SUBJECT: DEMONSTRATION / DELIVERY HOLD - Safety Recall 16S13
Certain 2015-2016 Model Year Transit Wagon Vehicles with Low Roof
Side Curtain Airbag Inspection and Adjustment

CERTAIN 2015-2016 MODEL YEAR TRANSIT WAGON VEHICLES WITH LOW ROOF — SIDE CURTAIN AIRBAG INSPECTION AND ADJUSTMENT

FIGURE 1

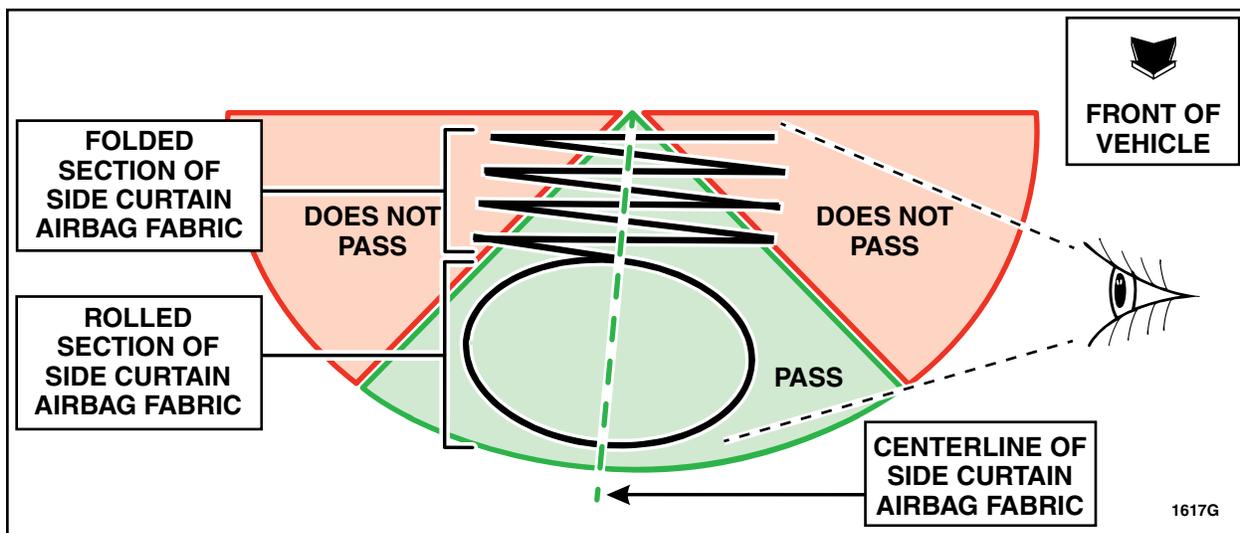
2. Inspect the driver and passenger side curtain airbag fold orientation starting at the B-pillar and ending at the rear of the vehicle. When properly positioned, the centerline of each side curtain airbag will have a rolled section of side curtain airbag fabric that should be positioned below the folded section. The side curtain airbag fabric orientation may be positioned anywhere within the acceptable (**PASS**) range illustrated in Figure 1.

The side curtain airbag **PASSES** inspection if the centerline of the rolled and folded sections is within the acceptable (**PASS**) range. See Figure 1 and 2a. If both the driver and passenger side curtain airbags pass inspection, the repair is complete. Install the rear headliner sections. Please follow the WSM procedures in Section 501-05 (rear headliner).

FIGURE 2

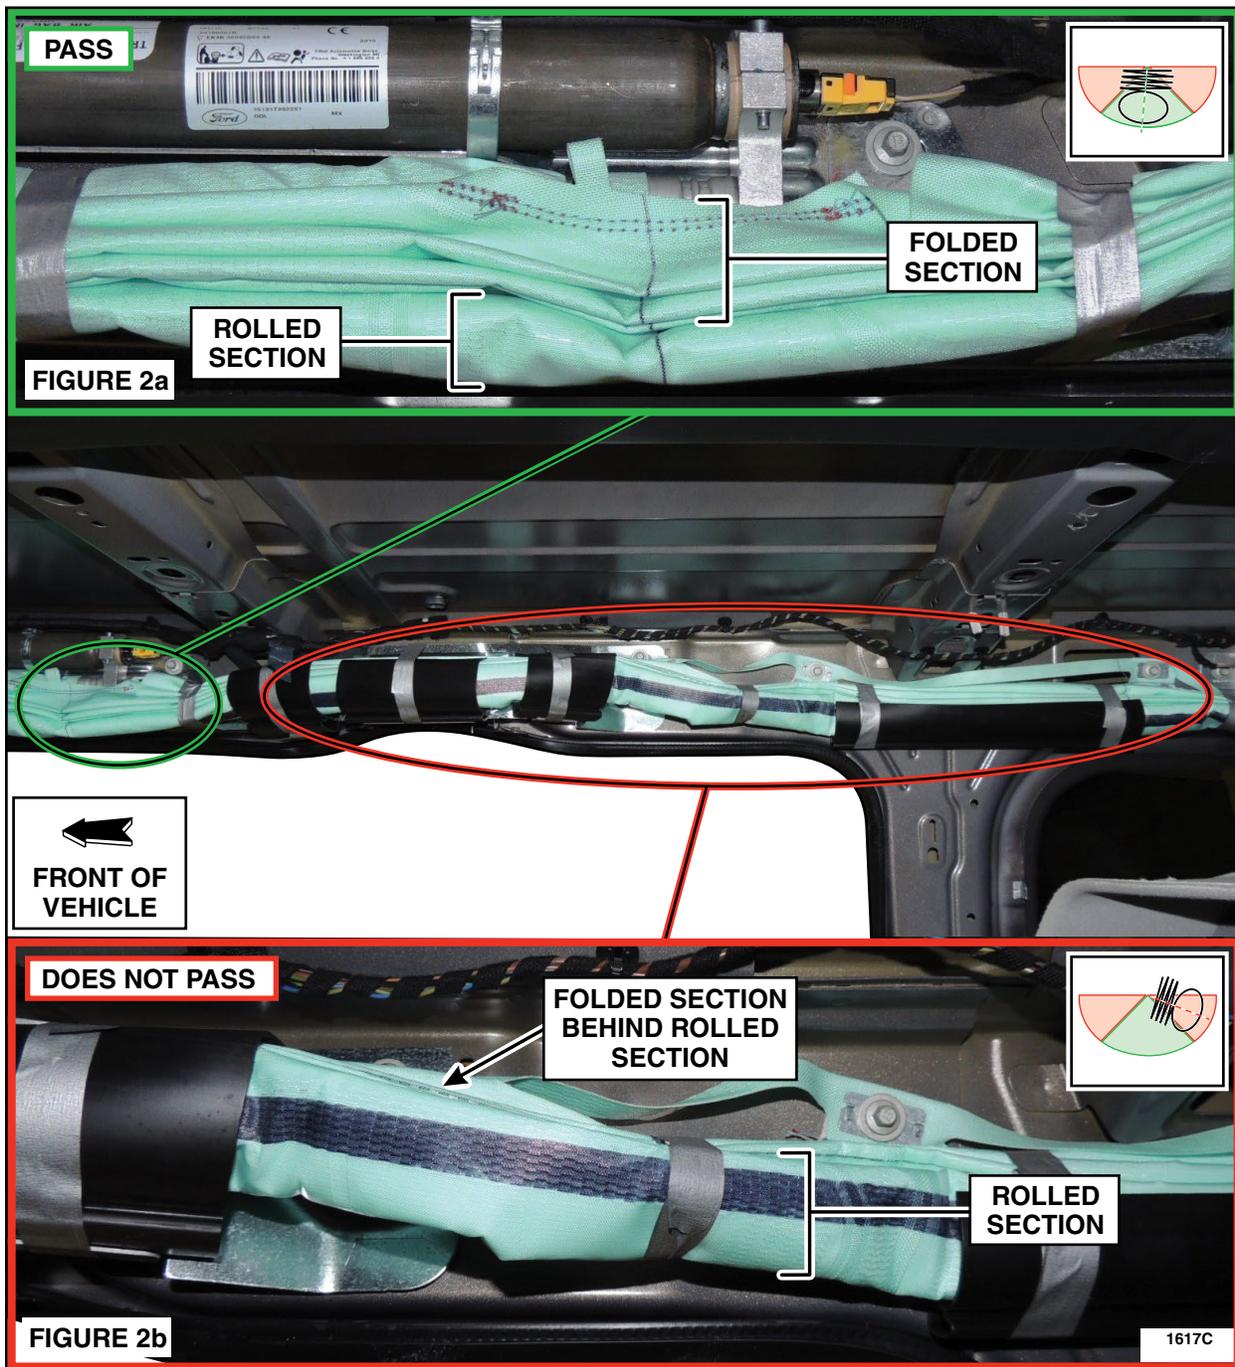
The side curtain airbag **DOES NOT PASS** inspection if the centerline of the rolled and folded sections is **not** within the acceptable (**PASS**) range at any point rearward of the B-pillar. See Figure 1 and 2b. If the side curtain airbag does not pass inspection at any point rearward of the B-pillar, proceed to the Side Curtain Airbag Adjustment Procedure on Page 3.

FIGURE 4

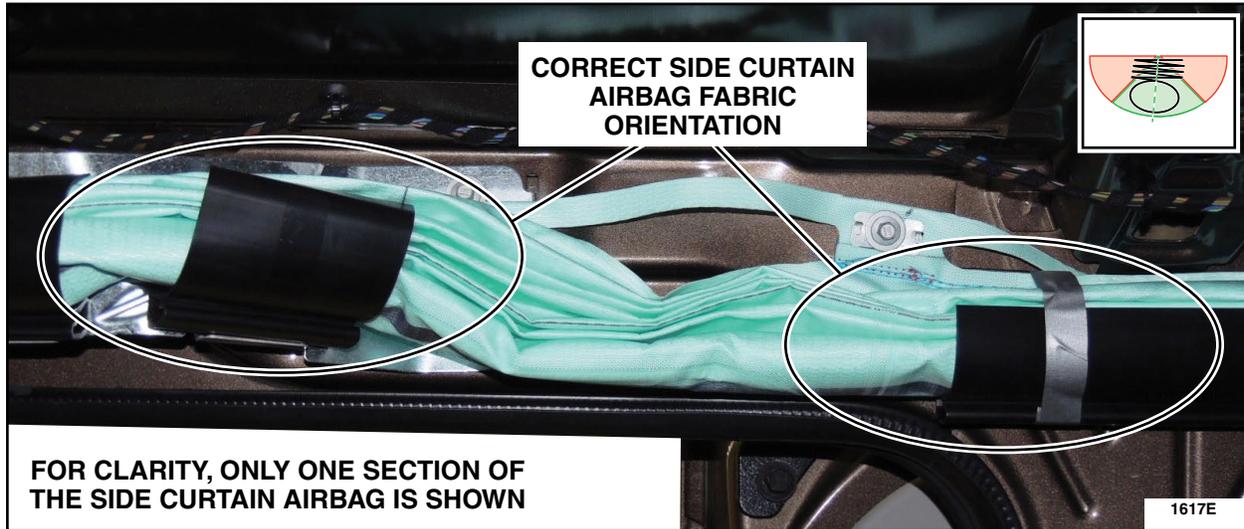
4. For all portions of the side curtain airbag that **DO NOT PASS** inspection, adjust the side curtain airbag fabric to match the correct orientation shown in Figure 4.

5. For each of the IPG[®] tape pieces removed from the factory locations, cut a 10 in (25.4 cm) piece of IPG[®] tape from the roll. Route the IPG[®] tape above the side curtain airbag fabric, going fully around, and overlap the IPG[®] tape ends at the bottom to secure the fabric. See Figure 5a and 5b.
